MECKLENBURG COUNTY
DEPARTMENT OF ENVIRONMENTAL HEALTH

SITE EVALUATION

Subject: Property located at 7908 Knollwood Circle
File: 21351

Subject. Property located at 7908 Knollwood Circle
File: 21351

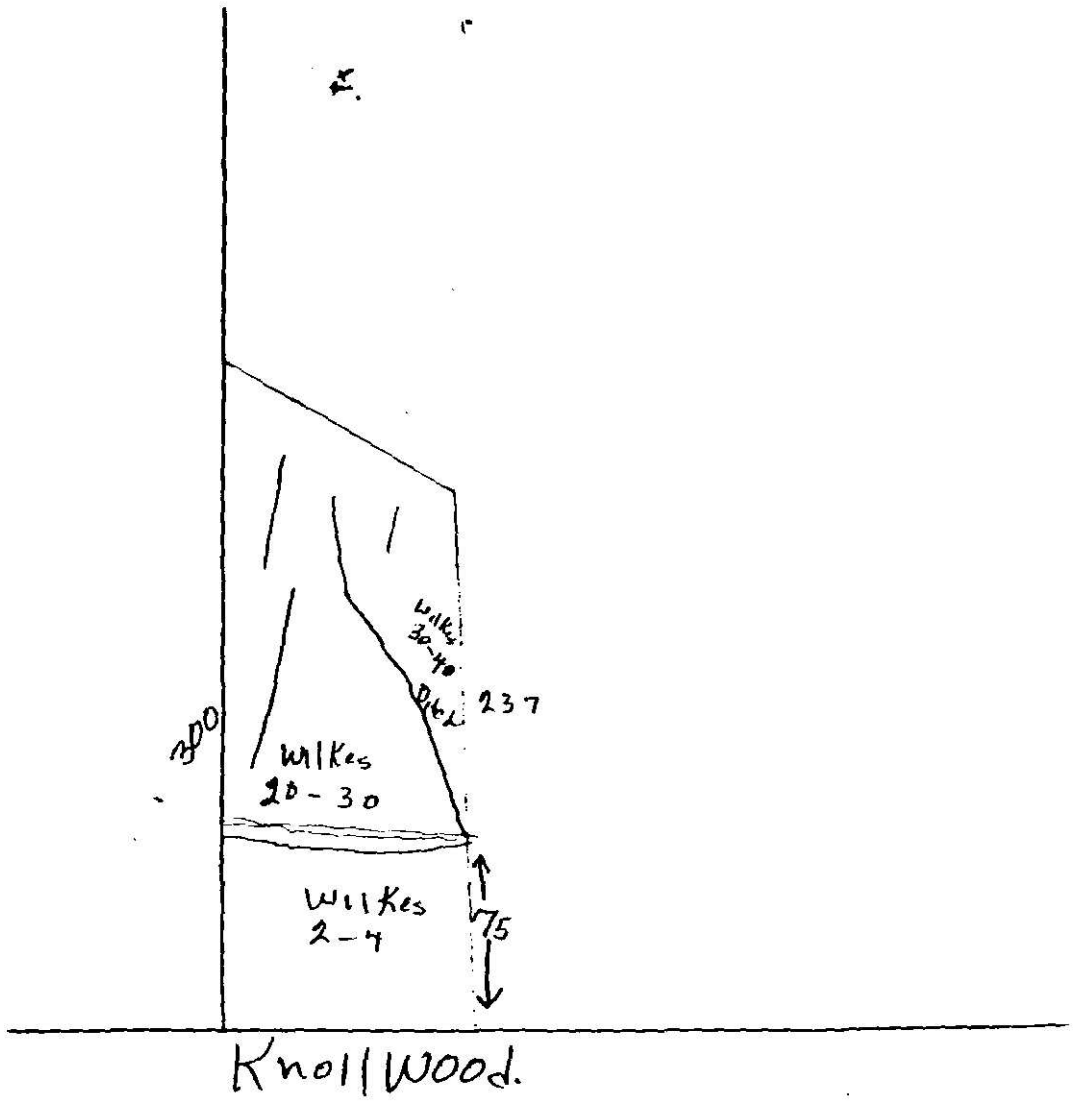
FACTORS	AREA 1	AREA 2	AREA 3	AREA 4
1. SLOPE (%)	S (PS) U — 2-4	S PS (U) — 11-30% To Complex	S PS U	S PS U
2. SOIL TEXTURE (12-36 inches) Sandy, Loamy, Clayey (Note 2-1 Clay)	S PS (U) — Mixed Clay	S PS (U) — Mixed Clay	S PS U	S PS U
3. SOIL STRUCTURE (12-36 inches)	S PS (U) — Weak Blocky	S PS (U) — Weak Blocky	S PS U	S PS U
4. SOIL DEPTH (inches)	S PS (U) — 18-20"	S PS (U) — 10-30	S PS U	S PS U
5. RESTRICTIVE HORIZONS (Inches) (Impervious strata, Rock)	S (PS) U — None	S (PS) U — None	S PS U	S PS U
6. SOIL DRAINAGE/GROUNDWATER (external and internal)	S PS (U) — Slow	S PS (U) — Slow	S PS U	S PS U
7. OTHER (Specify)	S PS U	S PS U	S PS U	S PS U
8. SOIL GROUP	IVB	IVB		
9. SITE CLASSIFICATION	Unsuitable	Unsuitable		
10. SOIL SERIES	Wilkes	Complex slope IN Wilkes

FRED F. TAYLOR
FILE 21351

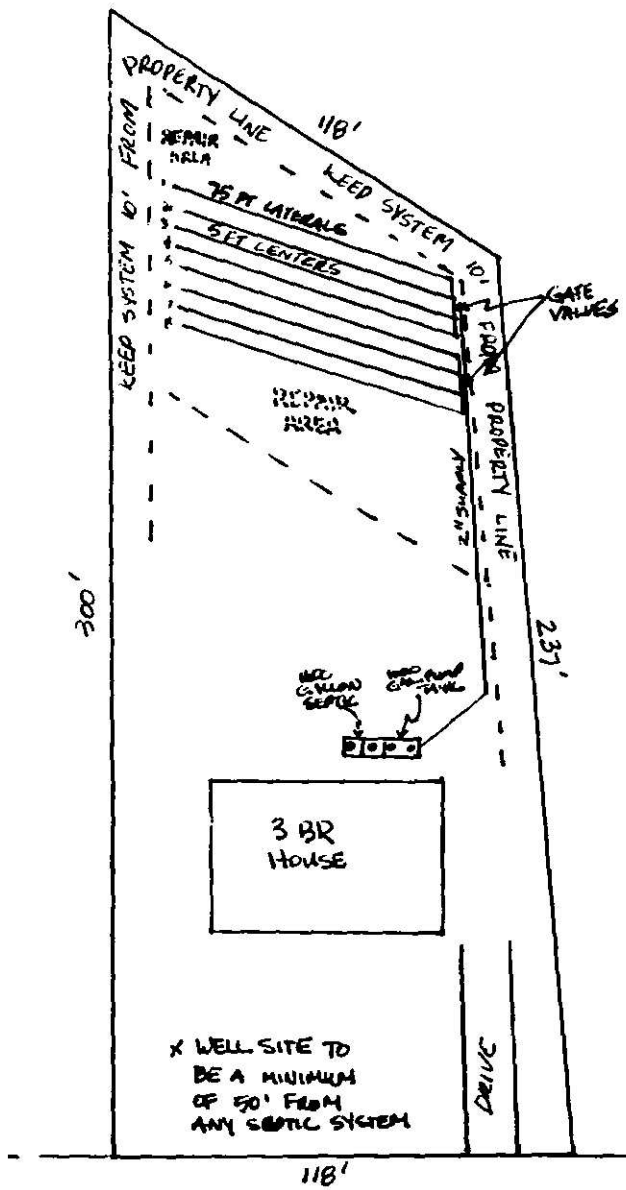
> The proposed system layout would be located in Area II as indicated by the site evaluation report. This area is unsuitable with respect to slope, texture, structure, and drainage. A low pressure pipe system cannot be reasonably expected to function properly in this area.

For these reasons, the plan as submitted has been disapproved.

FRED F. TAYLOR, OWNER
PROPERTY LOCATED AT
790X KNOLLWOOD CIRCLE

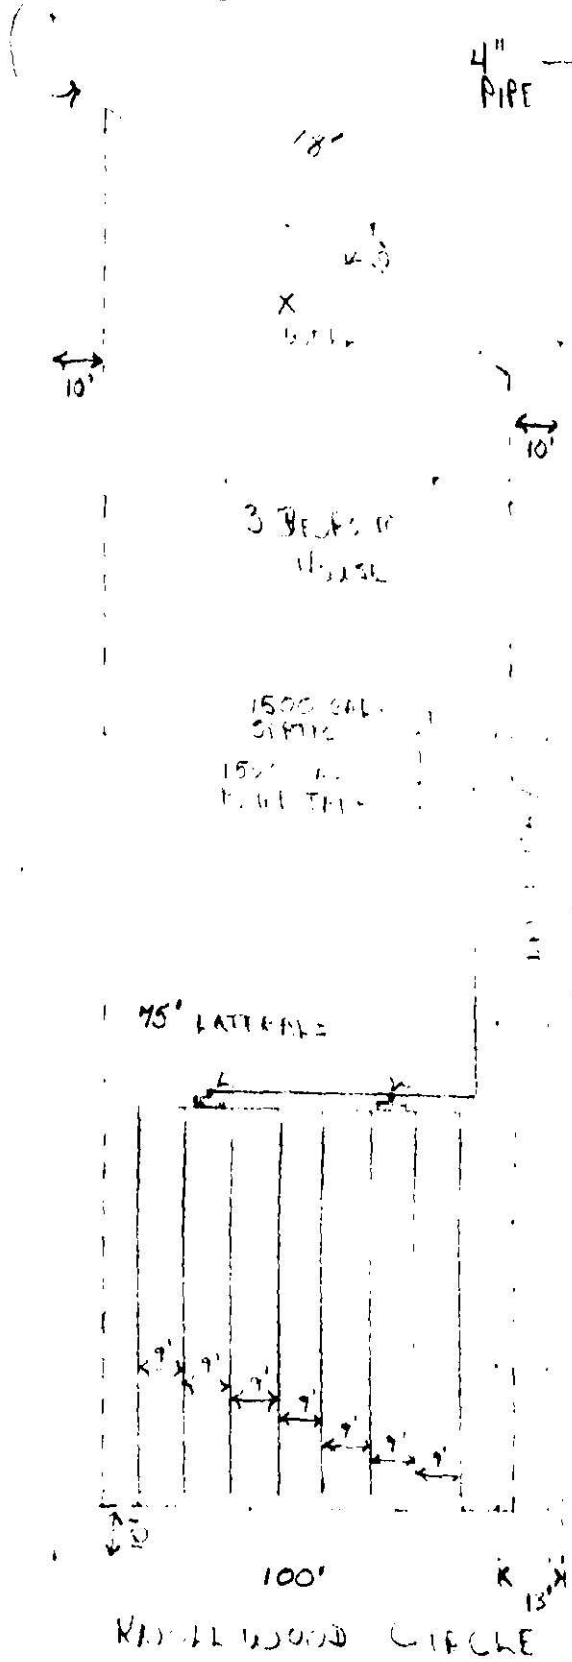
1. The site is classified as unsuitable according to the site evaluation report dated 8,17,84. The unsuitable factors include slope, soil texture, soil structure, soil depth, and soil drainage.

2. The topography on the site is unsuitable for the installation of a subsurface sewage disposal system.

3. It is felt that a subsurface sewage disposal system cannot be reasonably expected to function properly on this site.

For these reasons, the plans as submitted are disapproved.

DISAPPROVED
MECKLENBURG COUNTY ENVIRONMENTAL HEALTH DEPARTMENT
FILE NO. 21351
ICAR PERMIT NO.
DATE 10-13-87
BY S Ronin
